Fulton County, Indiana County Road 350 N

DRAFT Detailed Project Report and Environmental Assessment

SUBJECT: Approval of Draft Detailed Project Report & Environmental Assessment, Section 14
Project, County Road 350 North, Fulton County, Indiana

SHEET REFERENCE NUMBER:
CS102
SHEET ___ OF ___

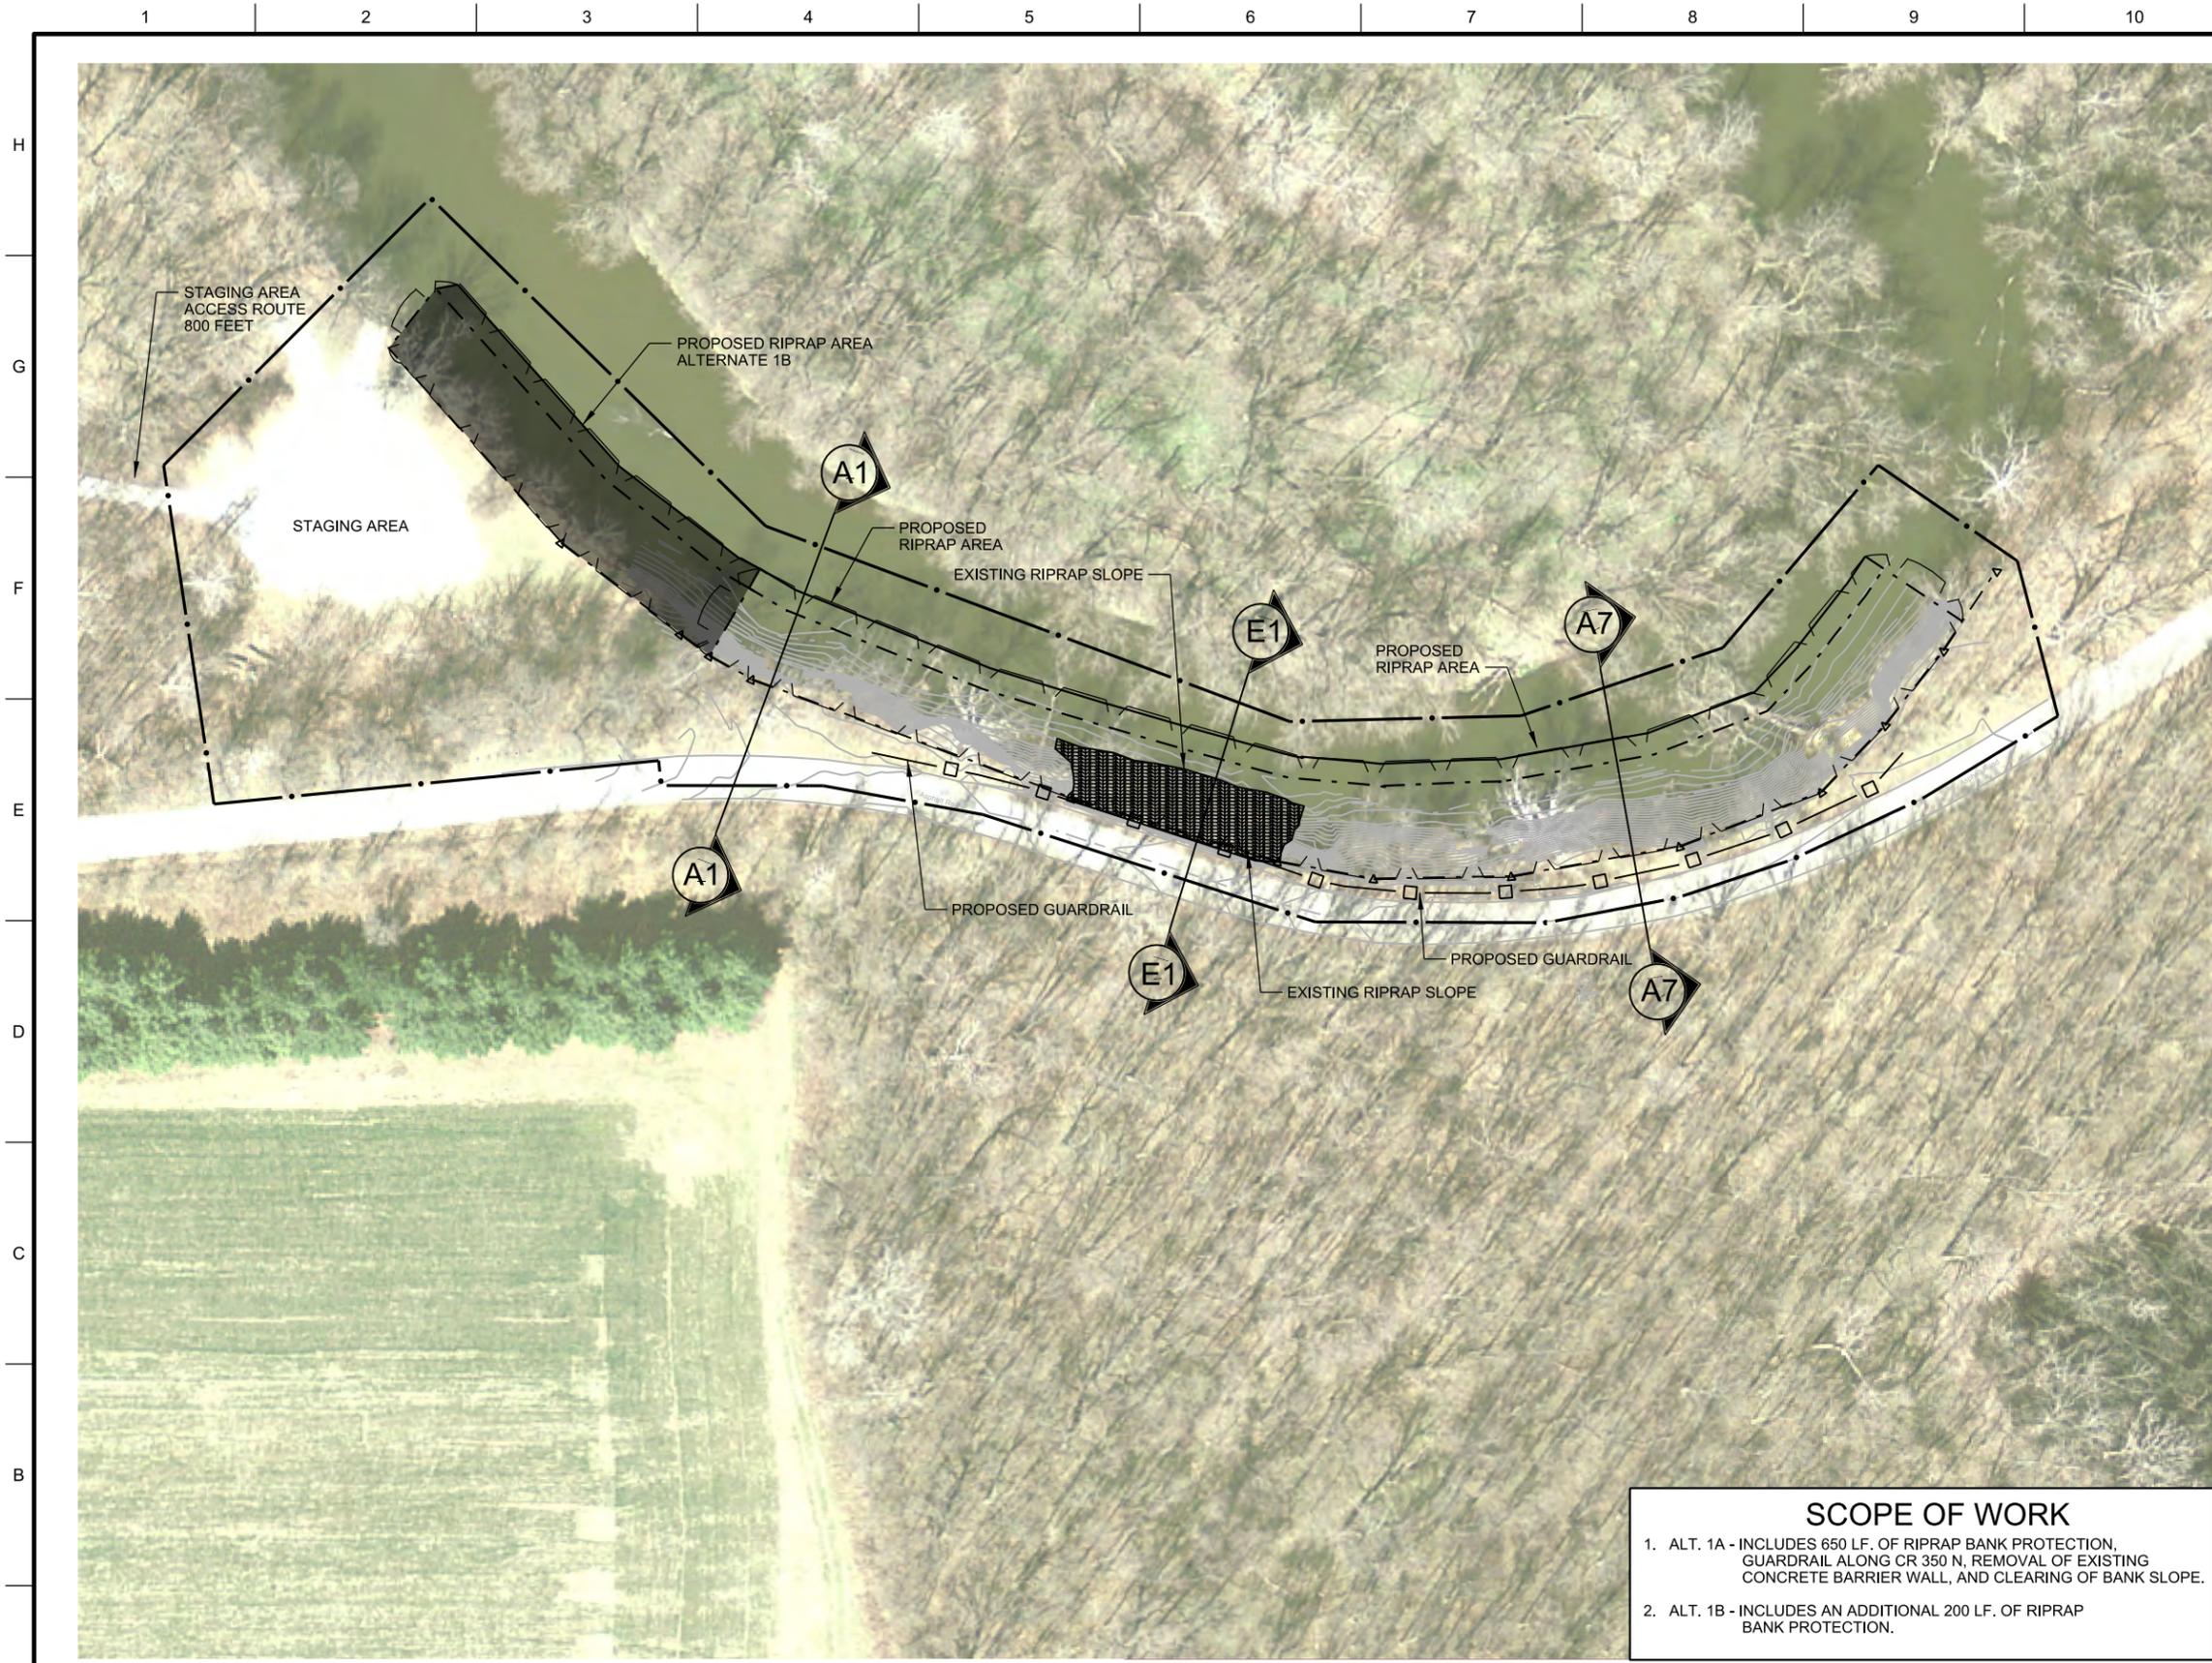
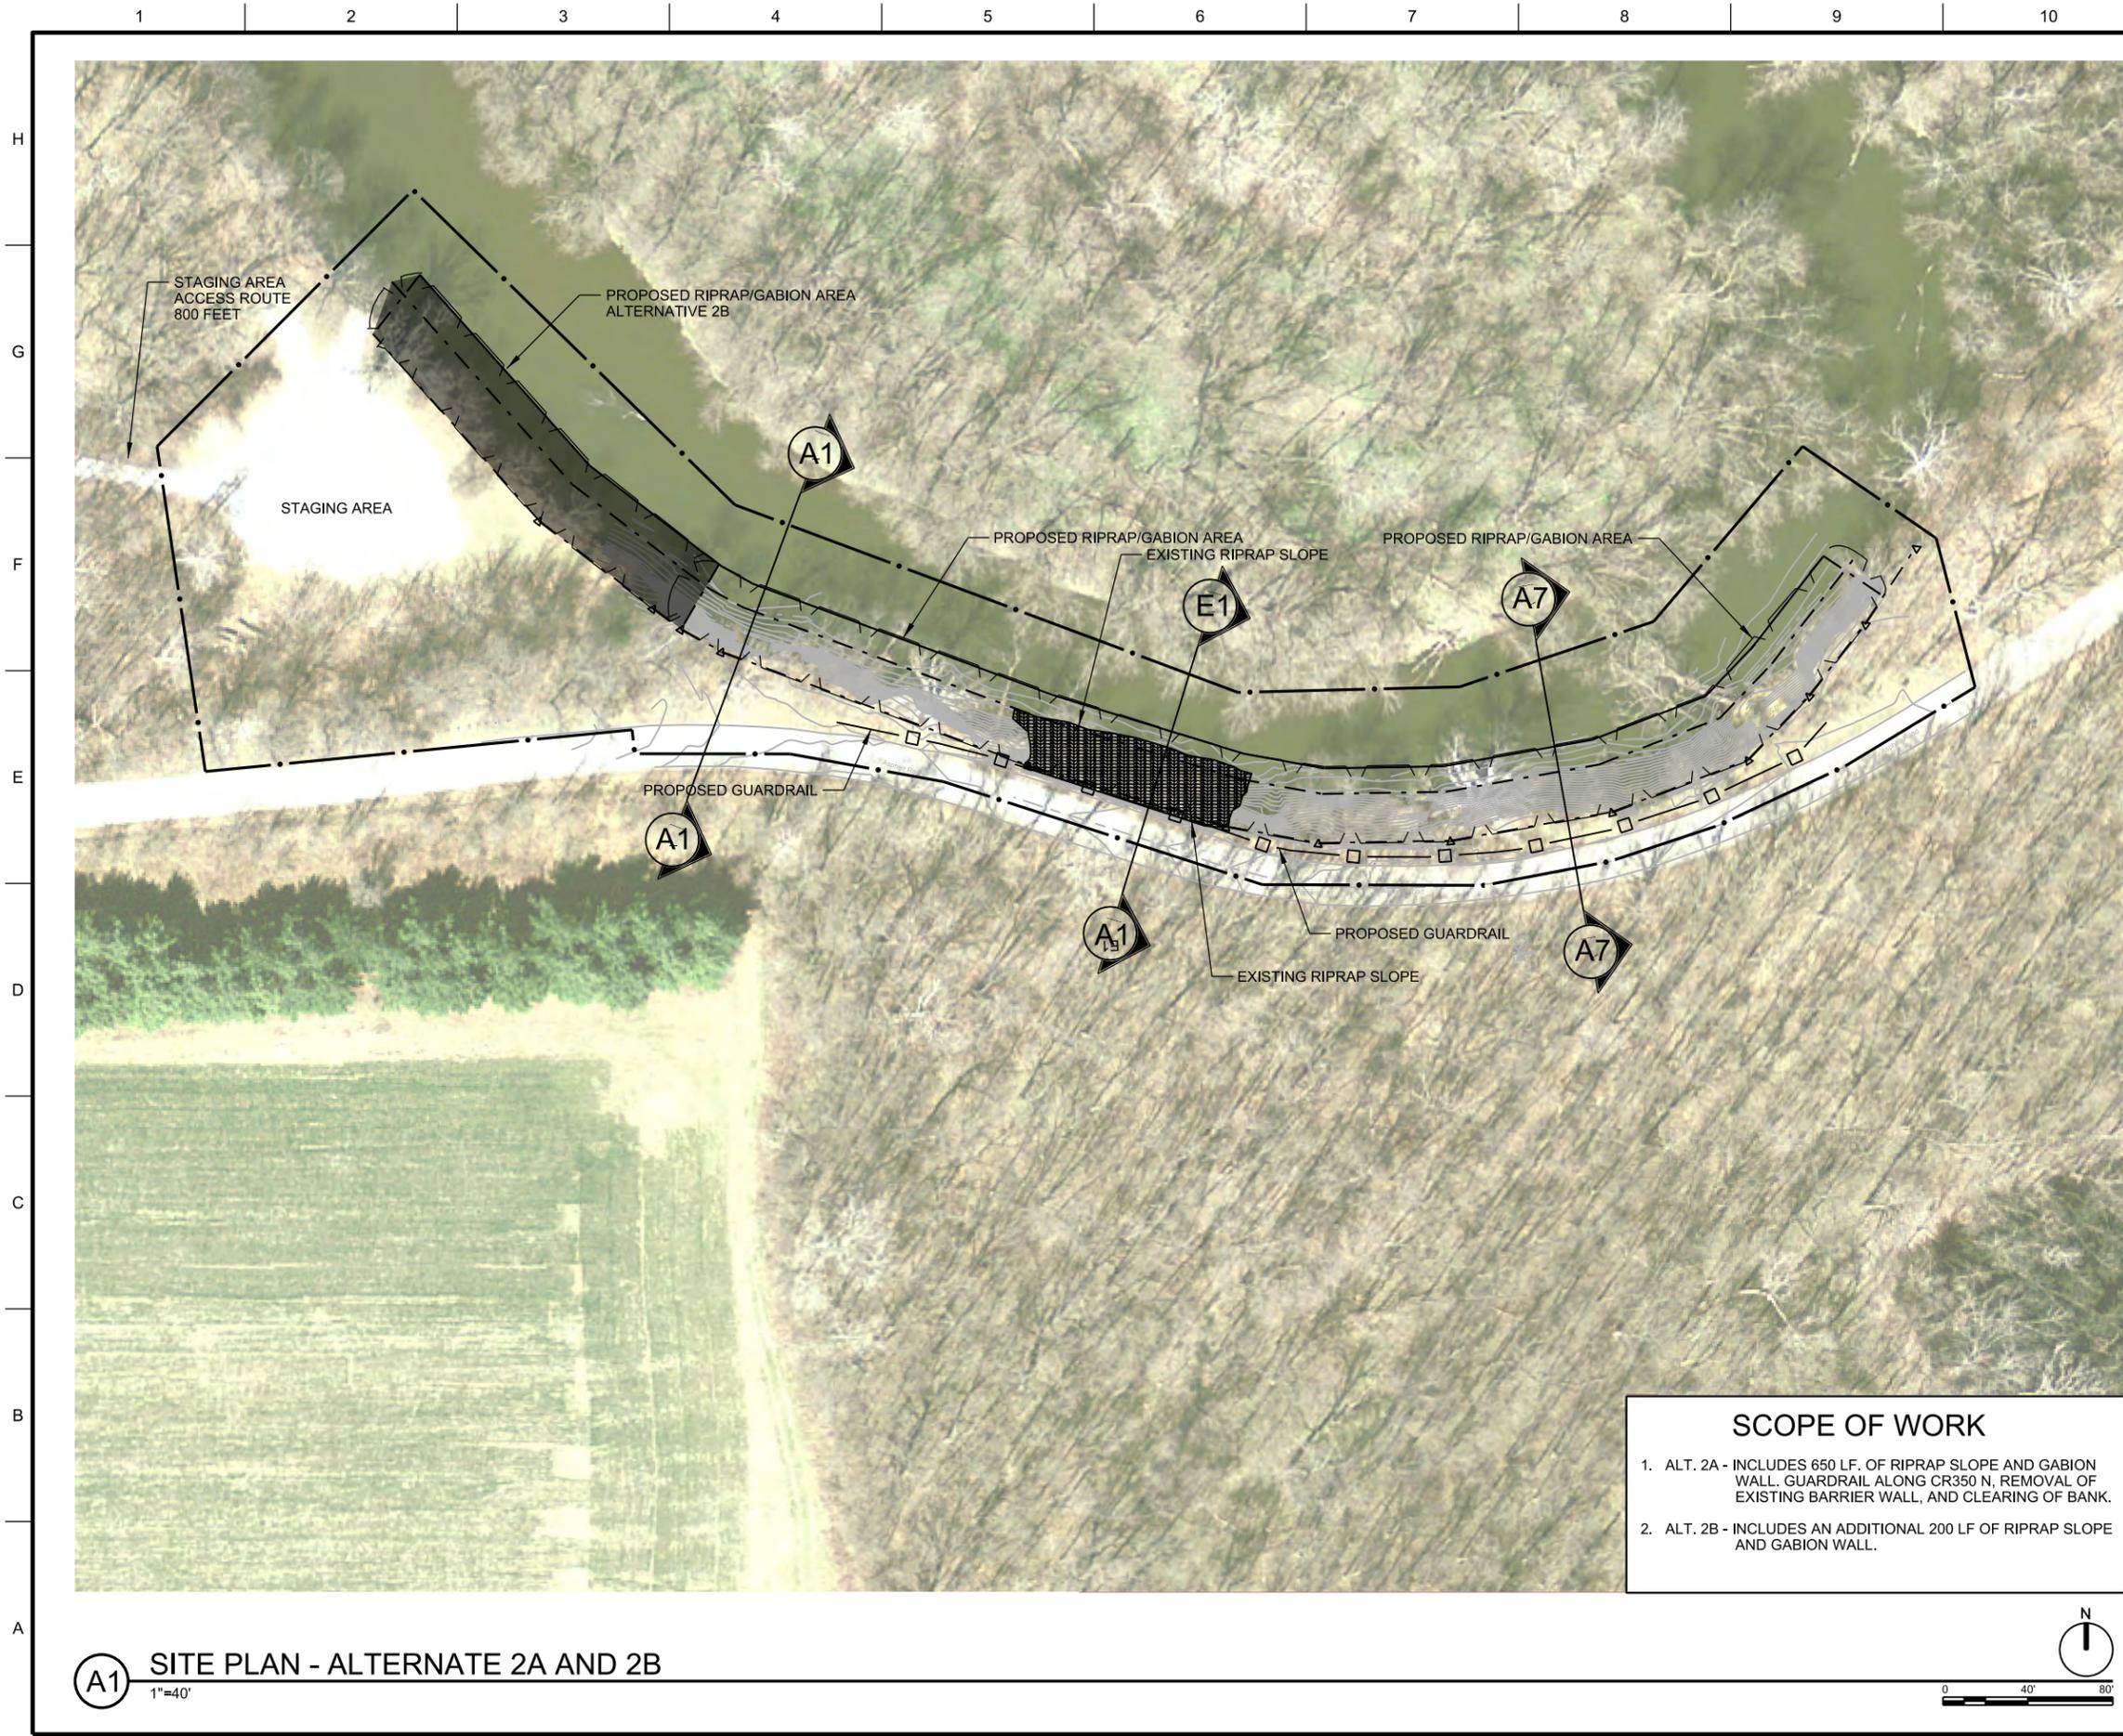
Sheet CS101-CS103: There are no cross-section cut lines shown in plan to locate the typical sections. Suggest adding the cross-section cut lines to the respective plan views.

Sheet CS103: The plan shows new riprap limits, but no new riprap is proposed for the marine mattress alternative. Presumably, this was a drafting oversight. Suggest removing the riprap line symbols from the plan and legend since none is shown on the typical sections. Also, the limit of the existing riprap to be covered by the mattresses should be shown on the plan.
